RIVERDALE CITY PLANNING COMMISSION AGENDA
CIVIC CENTER - 4600 S. WEBER RIVER DR.
TUESDAY – AUGUST 13, 2024

Body:	Planning Commission
Topic:	**Final Plat Extension Request** **Conditional Use Permit** **Site Plan Approval** Ken Garff Parking Lot – 667 W 4400 S
Department:	Community Development
Director:	Brandon Cooper
Staff/Presenter:	Brandon Cooper
Contact:	bcooper@riverdalecity.com

The applicant seeks approval of a Commercial Site Plan to construct a 44,355 square foot parking lot with 150 stalls and a 12,779 square foot landscape area. This site is a subdivided parcel once part of the Leslie's Mobile Home Park. All structures previously found on the site have been demolished or otherwise removed Below.

Staff Report

SHEET
C200

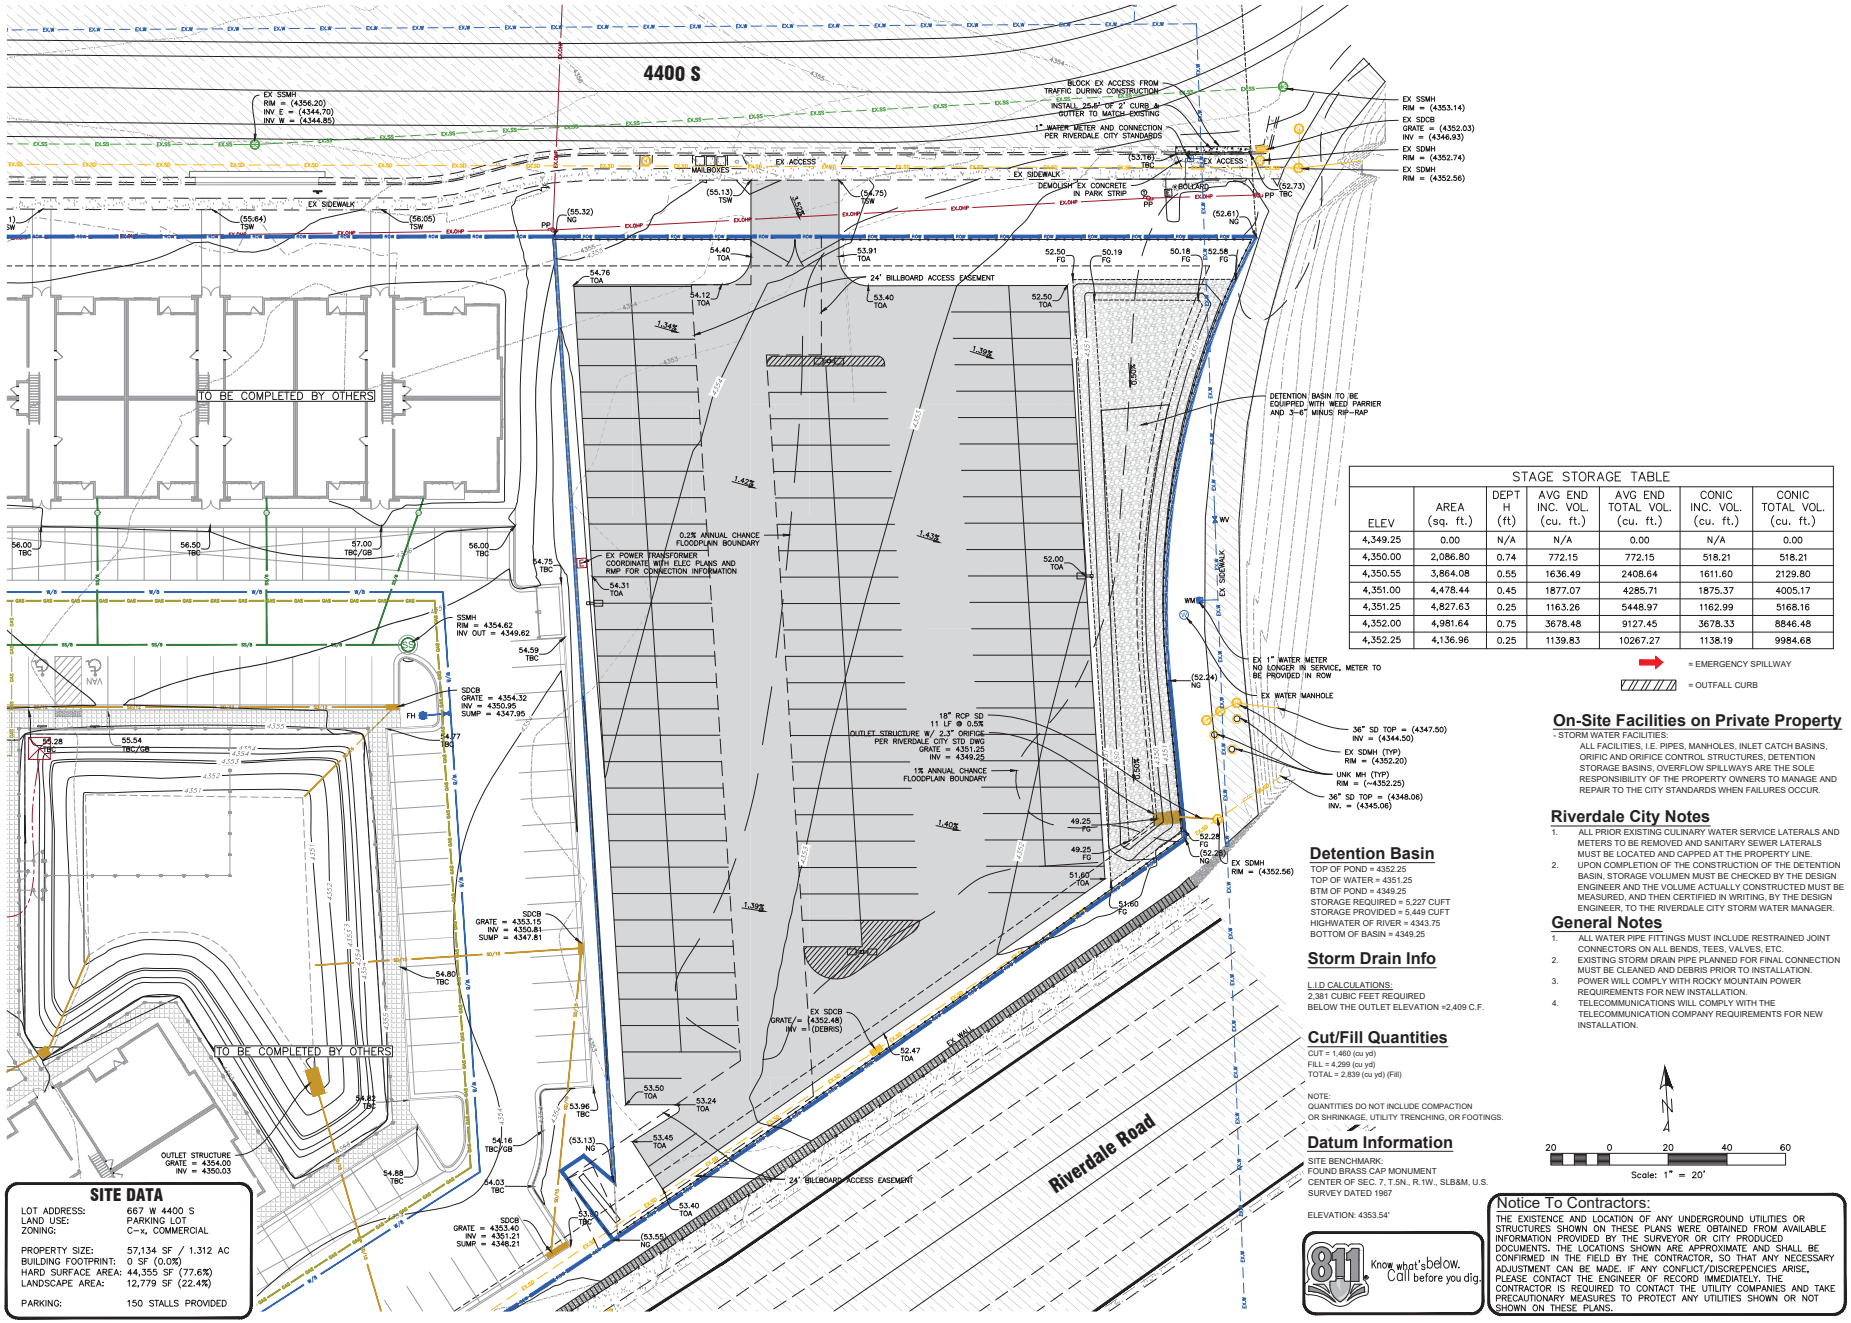
DATE	COMMENTS	CORRECTIVE ACTION	STATUS
06/10/2024	General Notes	Update all drawings to be current year and current month	Resolved
		On sheet C200 of the site plan, there is a call out for curb and gutter on the east side of the parking lot. Will curb and gutter be placed around the entire parking lot?	Resolved
		Where is the water meter going to be located and what size?	Resolved
		On sheet C600 Civil Details, the storm water calculations are using a different area for paving and landscaping than shown on other sheets. Please update accordingly and adjust storm water calculations	Resolved
		The overflow spillway appears to be at the location of the outfall box. As the water discharges, is there material or a path to control the overflow? The overflow appears that it will cross UDOT property and across the asphalt trail – if so, need approval from UDOT PLEASE RESOLVE AT OR BEFORE THE PRE-CONSTRUCTION MEETING PRIOR TO ANY WORK BEING DONE ON THE SITE	Not Resolved

Sheet C200 shows the installation of new 8’ chain-link fencing with slates on the north side and east side. Maximum height is limited to 7’. Does this fence run the entire perimeter of the property? If so, please indicate. Please provide specification and color for slat material	Resolved
		Any fence over 6’, up to a maximum fence height of 7’, must have engineering provided by the installation contractor or supplier WE WILL NEED THE ENGINEERING AT OR BEFORE THE PRE-CONSTRUCTION MEETING PRIOR TO ANY WORK BEING DONE ON THE SITE	Not Resolved
		Please show in plans access easement to billboard sign PLEASE HAVE THIS WORKED OUT PRIOR TO PRE-CONSTRUCTION OR ANY WORK ON THE SITE	Not Resolved
